## **Amendments to the Drawings:**

### **REMARKS/ARGUMENTS**

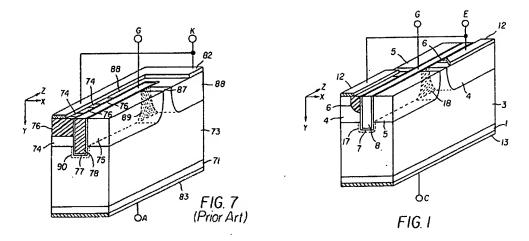
The Examiner indicates that the APA fails to teach or suggest a floating second well region as recited in applicants' claim 14, and then attempts to overcome this deficiency by combining what the Examiner terms as the "well region floating (5)" in Fig. 1 of Iwamauro with prior art Fig. 2A of the present application. The Examiner then states:

Underline is added. This is respectfully traversed because well region 5 in Fig. 1 of Iwamuro does <u>not</u> reduce the ON resistance. Rather, well region 5 helps reduce the turn-off storage time of the device by forming p channels 17 and 18 with adjacent p well regions 4. Incorporating well region 5 in the Fig. 2A structure of APA in the manner taught by Iwamura would not yield a structure where well region 5 can form p channels with its adjacent regions as in Iwamuro, and thus the reduced turn-off storage time would not be realized. The n-type JFET

region 210 in Fig. 2A (which is doped higher than drift region 106 to reduce the device ON resistance), would further block formation of such p channels in the Fig. 2A structure. Thus, as set forth in more detail next, Iwamuro fails to provide any motivation for combining well region 5 with APA in the manner suggested by the Examiner.

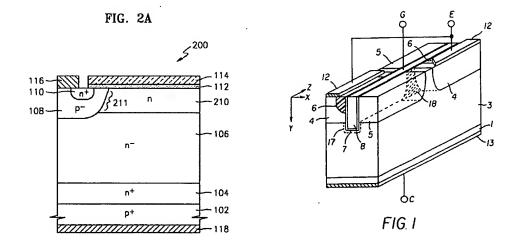
In Fig. 1 of Iwamuro, well region 5 is carefully integrated in the structure so that when the device is turned off, p channels 17 and 18 are formed between well region 5 and its adjacent well regions 4 (see column 7, lines 52-59). P channel 17 in Fig. 1 is formed directly underneath the gate trench and p channel 18 is formed along the trench sidewall. During turn-off

Applicants contend that well region 5 of Iwamuro can not be combined with the prior art structure in Fig. 2A of the present application for the purpose of obtaining a fast turn-off storage time because the two p channels required for the fast turn-off storage time would not be formed in the resulting structure. The two p channels would not be formed because of the significant structural differences between the device in Fig. 1 of Iwamuro and the prior art device in Fig. 2 of the present application. These two figures are reproduced below for comparison.

As can be seen, gate 114 in Fig. 2A extends laterally over a surface of the semiconductor. In contrast, gate 8 in Fig. 1 of Iwamuro is embedded in a trench extending

vertically into the semiconductor. In Fig. 1 of Iwamuro, when the device is turned off, p channel 17 forms directly under the trench housing gate 8, and p channel 18 forms along the trench sidewall between well region 5 and well region 4. Because the structure in Fig. 2A (particularly the gate) is very different from that in Fig. 1 of Iwamuro, integrating well region 5 in Fig. 2A of the application as taught by Iwamuro would not yield a structure where p channels can form during turn-off time, and thus the reduced turn-off storage time would not be realized. Further, in Fig. 2A of the present application, n-type JFET region 210 (which is doped higher than the drift region 106 to reduce the device ON resistance) prevents formation of a p channel between p region 108 and a well region incorporated therein. To this extend, Fig. 2A teaches away from including therein well region 5 for purposes of forming p channels during turn-off time.

FIG. 2C (PRIOR ART)

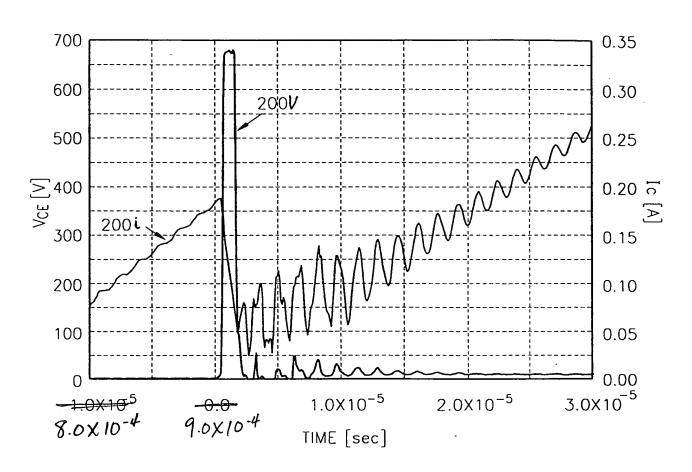
The attached four (4) sheets of drawings include changes to Figs. 2C, 4A, 4B, and 4C. In Fig. 2C, the time indicators "0.0" and "-1.0X10<sup>-5</sup>" along the time axis are changed to --9.0X10<sup>-4</sup>-- and --8.0X10<sup>-4</sup>--, respectively. In Figs. 4A, 4B, and 4C, the reference characters not mentioned in the specification have been deleted. These sheets, which include Figs. 2C, 4A, 4B, and 4C, replace the original sheets that includ Figs. 2C, 4A, 4B, and 4C.

Fig. 2C has also been amended to correct inadvertent errors, namely, the time indicators "0.0" and "- $1.0\times10^{-5}$ " along the time axis have been changed to -- $9.0\times10^{-4}$ -- and -- $8.0\times10^{-4}$ --, respectively. This corrects what would otherwise be a nonsensical time scale.

FIG. 4A

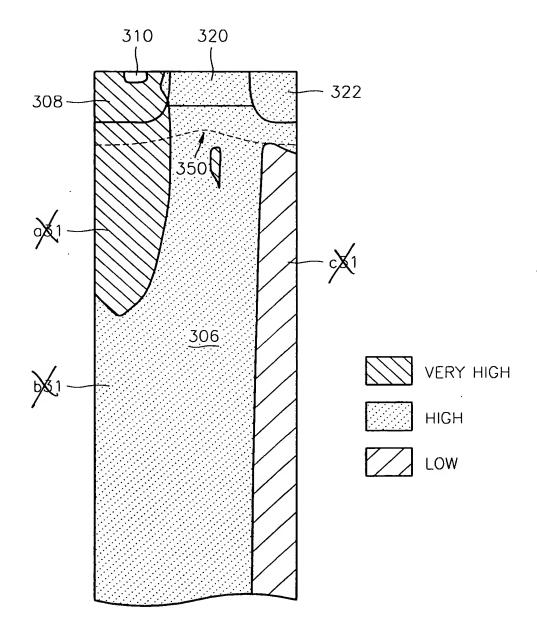
Figs. 4A, 4B, and 4C are objected to for including reference characters not mentioned in the specification. As shown in the attached amended drawings, the reference characters not mentioned in the specification have been removed from Figs. 4A, 4B, and 4C.
